**Re: The Garages, Frogna Lane, London NW3 6DN**

This Accompanying Letter (AL) was prepared following to the issuing of Basement Impact Assessment Rev2.2 (report ref. 21109/BIA Rev2.2, dated September 2024) and subsequent comments from Campbell Reith, received by email only on 26<sup>th</sup> September 2024.

Figure I – Damage Category,  $L/H = 0.5$

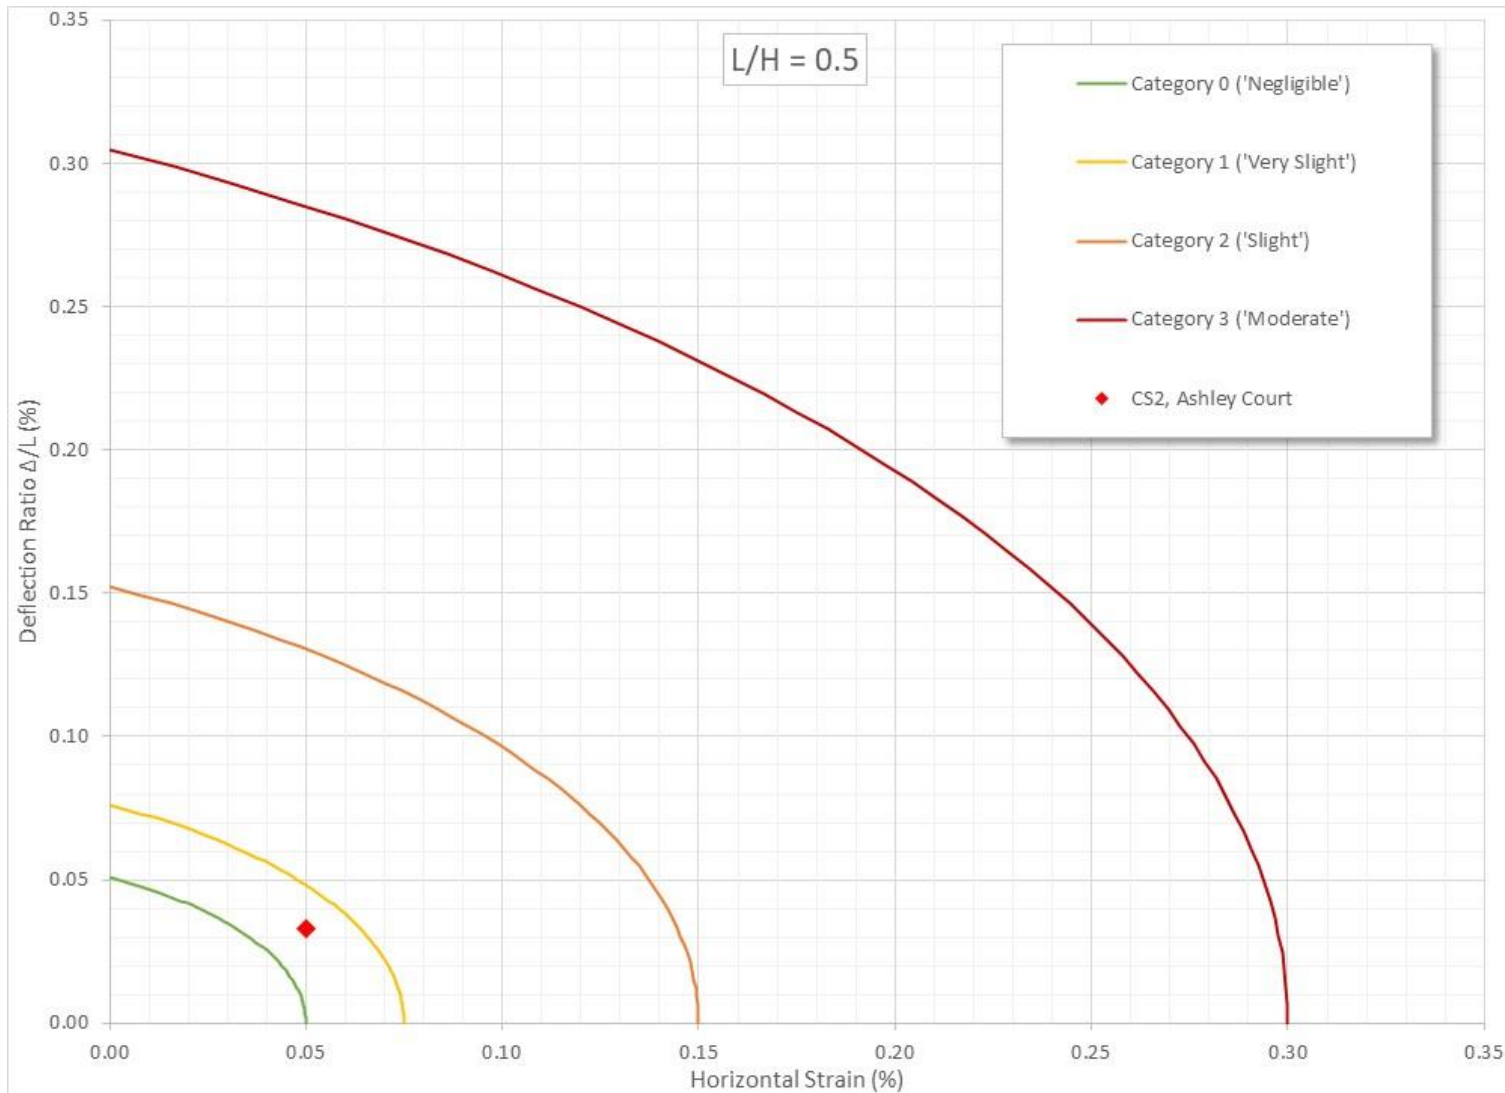
- 4. Table 10.6 of the BIA lists the L/H ratios for CS1 and CS2. The damage categories are shown on the plot for L/H=1, despite the L/H ratio of CS2 being 0.64. It is requested that the damage category plot for CS2 use the category boundaries for L/H=0.5.*

The average height of the building at Ashely court was evaluated considering the change in elevation between front and rear of the building and estimated as circa 22.5m. The L/H ratio was therefore amended as 1.24. In that case, the assessment of the damage category could be done using the plot for L/H = 1.0 and presented in Figure 28 of BIA Rv2.3.

However, just as an example, in Figure 1 at the end of this AL the evaluation of the damage category for CS2 only was presented using the plot for L/H =0.5, where it can be observed that the expected damage could be restrained to fall in Burland category 1 (very slight damage) despite of the various conservative assumptions adopted in the calculations.
